12th April, 2023

Eastern Creek Lot 3 Outlet Centre Detailed Design Feedback

These comments have been prepared on behalf of CAMWEST, a Bicycle NSW affiliated Bicycle User Group with a focus on advocating for and encouraging cycling in the Penrith, Blacktown, Parramatta, and Cumberland council areas of Western Sydney.

Figure 1 - Marked up partial copy of 'Stage 3 Proposed Floor Plan', page 15 of Appendix D - Architectural Drawings

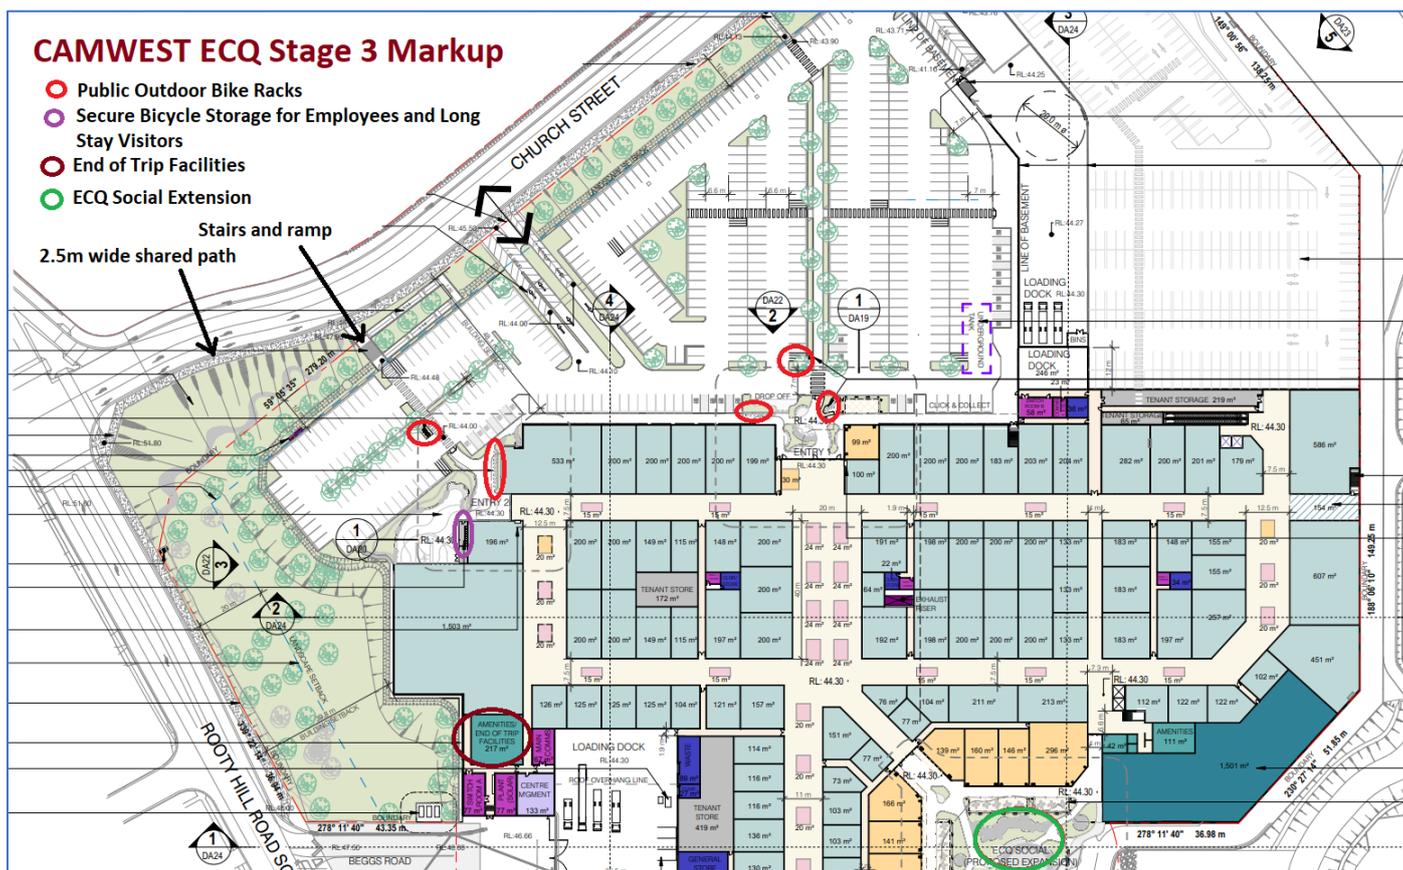
1. While welcoming the inclusion of 16 secure 'Employee' bicycle parking spaces and 68 public 'visitor' spaces, we question whether these are actually meeting the current and future requirements of those visiting the centre.

- a. The allocated spaces appear to be for 'standard' bikes. Bikes are increasingly coming in many different forms and configurations. There are longer than standard 'cargo' and tandem bikes, and cargo tricycles just to mention a few. Some bikes come with a stand, so don't require rails to lean up against for support but may require a rail for locking to. Where usable cycling infrastructure exists both to and within a shopping precinct, we would expect the use of cargo bikes to increase over time.

- b. The current planned 'Secure' and roughly 40% of the 'public' spaces are close to Entry 2. The direct access to this area from Church St involves stairs or a DDA Compliant ramp with 90 degree turns. This may not be ideal for some bike riders. We were unable to see the width of the ramp marked on the drawings, but if scaling is correct it appears to be a lot narrower than the minimum standard 2.5m shared path. Would it be wide enough for users travelling in the opposite direction to pass? We have our doubts. We would like consideration given to either widening/improving the current ramp, or to building another ramp to Church St or RHRS for use by bike riders.

2. As mentioned above, we believe a significant number of the 'Social/Fitness' cohort may be unwilling to leave their bikes in the 'public' outside areas while they duck in for a beverage and/or something to eat. I suspect some in the 'Shopping' cohort may be in the same boat. We would like consideration given to:

- a. Creating some bike parking areas in the extended ECQ social area, close to where riders may be sitting.
 - b. If possible, create a path/ramp into this area using part of the 6.5-7.5m wide area around the perimeter of the building along the corridor from Church St marked on the above plan as 'RFS VEHICLE ROUTE AROUND BACK OF SITE (EASEMENT)' (See brown line on Figure 4).

- c. Create more secure bicycle parking, possibly in the underground carpark.

3. The proposed shared path along the south side of Church St crosses both the entrance and exits to the above ground and underground parking areas. With parking for 1171 vehicles, there is potential for a lot of vehicular movements across this path.
- Diverting the riders from the M7 path who wanted to go to ECQ Social around the RFS Vehicle route (as above) would remove some of the riders crossing one or both driveways.
- We would like to see an additional shared path constructed on the northern side of Church St, so those who wish to traverse between RHRS and the M7 path could avoid the driveway crossings into the precinct.

Figure 2 - Marked-up partial copy of Drawing 15766_DA_C100, Appendix I page 2.

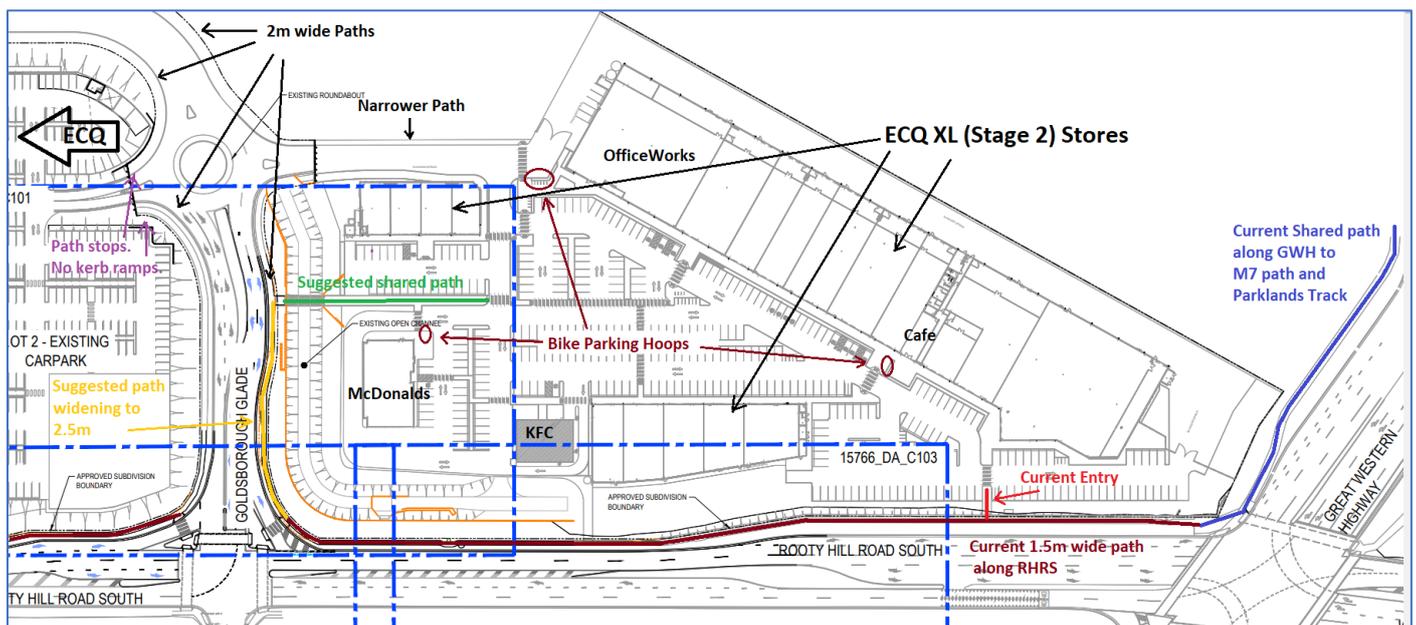
Assuming this is the case, we'd like to see at least one more cycle accessible entrance to ECQ XL. Probably the most logical is widening the southern side of Goldsbro Glade between RHRS and the Pedestrian bridge over the open channel to 2.5m (Orange line on Figure 2 above) and allowing riders to ride across the bridge and along the path as far as the zebra crossing (Figure 2 Green line). This would take riders close to entrances to McDonalds and to a lesser extent KFC. Although not ideal, they could walk across the zebra crossings to the bike hoops near Officeworks.

Looking South to GWH along RHRS, where the 1.5m wide path widens. 'Bike Lane Ends' sign facing the wrong direction.

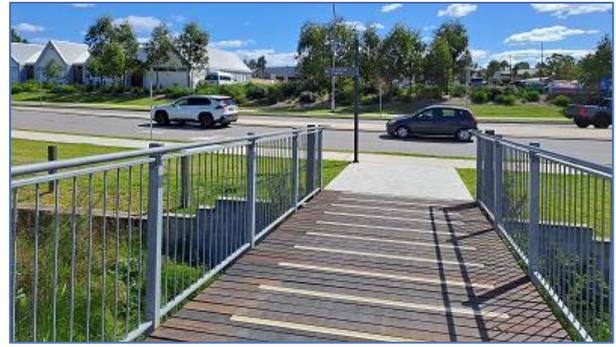
Despite being constructed recently, the existing path along RHRS (between the bus stop opposite Cawarra St and the Great Western Hwy) is only 1.5m wide.

Looking south towards ECQ XL on footpath along Goldsbro Glade

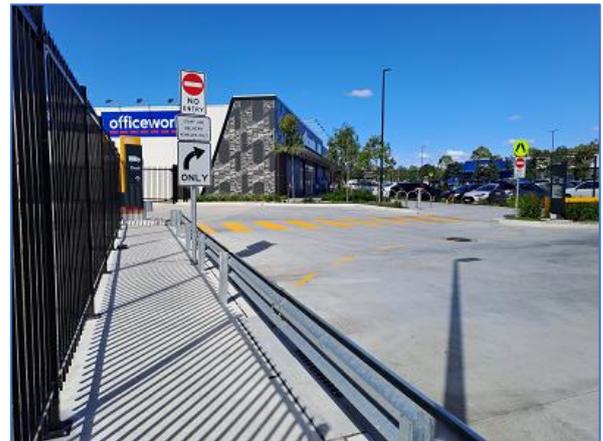
There is a path along the eastern side of Goldsbro Glade between ECQ and ECQ XL. At the ECQ end this is 2m wide, but at the roundabout it narrows. This photo was taken from the path looking towards ECQ XL and the bicycle parking hoops near Officeworks. If this path were wider it could be quite a useful link between the existing two precincts and potentially Stage 3 as well. However, due to this paved area being built-up above the natural ground level, we think widening would be knocked back on cost grounds.

Figure 4 – Suggested paths leading into the northern section of the precinct.

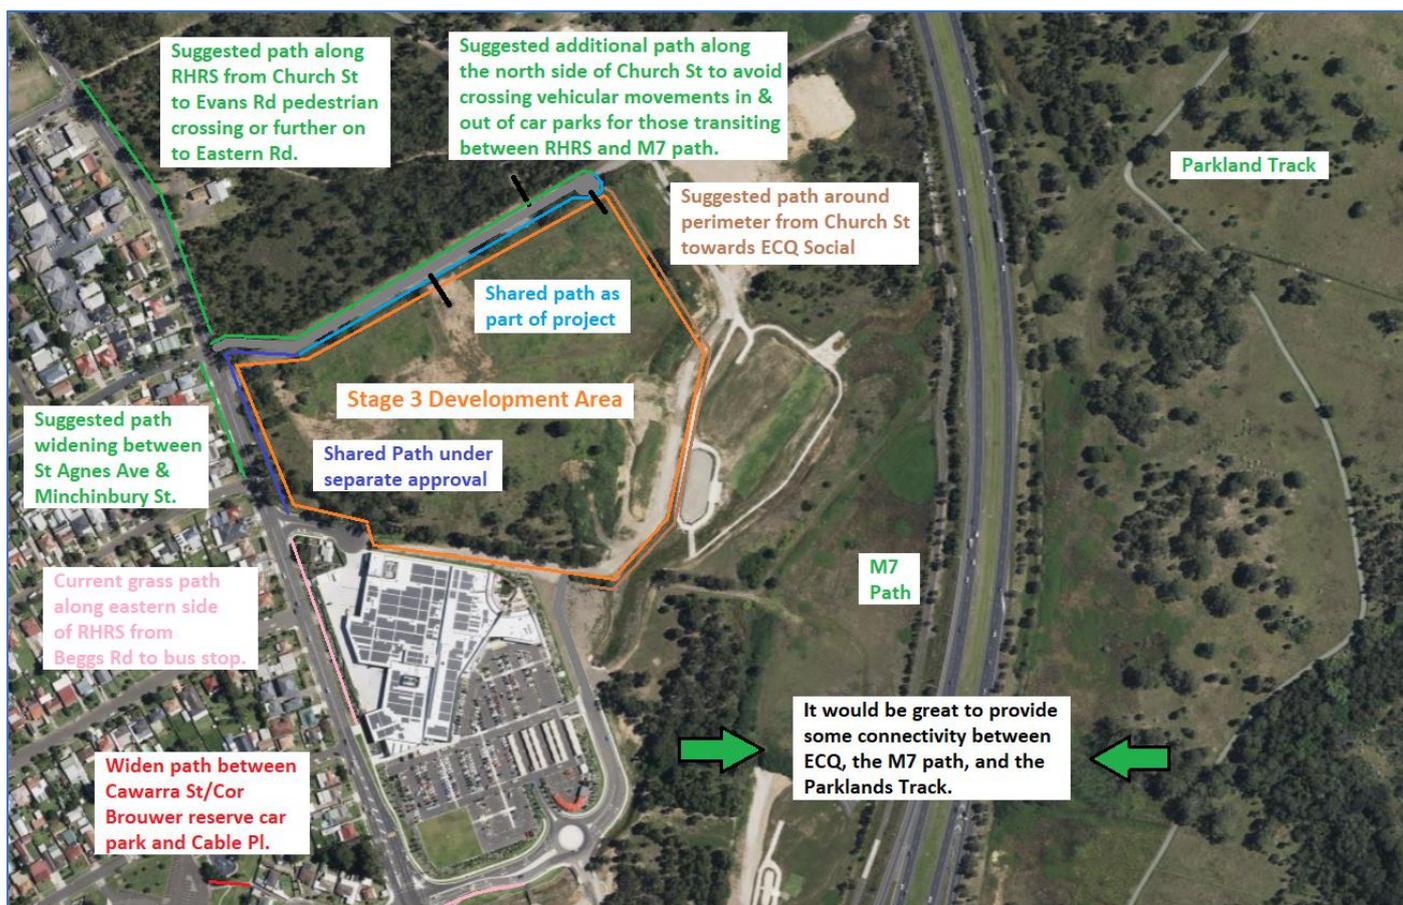
1. The above map shows two segments of shared path already outlined in the detailed plan:
 - a. The shared plan along the south side of Church St until the realignment curve (light blue line).

- b. The extension, presumably by TfNSW, for the remainder of Church St and then around into RHRs and heading south as far as Beggs Rd (dark blue line).

2. As proposed in Appendix R above:
 - a. The continuation of the shared path from Beggs Rd to the start of the current 1.5m path at the bus stop opposite Cawarra St (Mauve line)

- b. The widening of the current footpath between the bus stop and the GWH, crossing over Goldsbro Glade. The crossing lanterns at this intersection should be changed to combined pedestrian/cycling lanterns.

3. The construction of a shared path along the northern side of Church St, so riders traversing between RHRs and the M7 path don't have to cross the Stage 3 above ground and underground car park driveways.

4. Widen 110m of current footpath on the western side of RHRs between Minchinbury St and St Agnes Ave to shared path width. This would provide a relatively low traffic route from Minchinbury St (and the Minchinbury suburb on the other side of the GWH) into the precinct.

5. Build a shared path along the eastern side of RHRs north from Church St to at least Evans Rd pedestrian lights or preferably up to Eastern Rd.
6. Use combined pedestrian/bicycle lanterns on the new signalised intersection of Church St, St Agnes Ave and RHRs.

7. Build a path around the external walls of Stage 3 to bring riders from Church St into ECQ Social (Brown line).
8. Particularly if 7 can't be accomplished, build a more direct path from ECQ (and in particular ECQ Social) to the M7 path.

9. If logistically possible and not too expensive, provide a connection from the Parklands Track under or over the M7 onto the M7 shared path. This should be closely aligned with 8, so the residents of Bungarribee have the shortest practicable route into the ECQ precinct. The best place for an underpass of the M7 may be near the GWH toll gantries.
10. Either build a new shared path from Cawarra St to Cable Place through Cor Brouwer Reserve or widen existing 1.5m path which runs from the reserve car park to Cable Place.
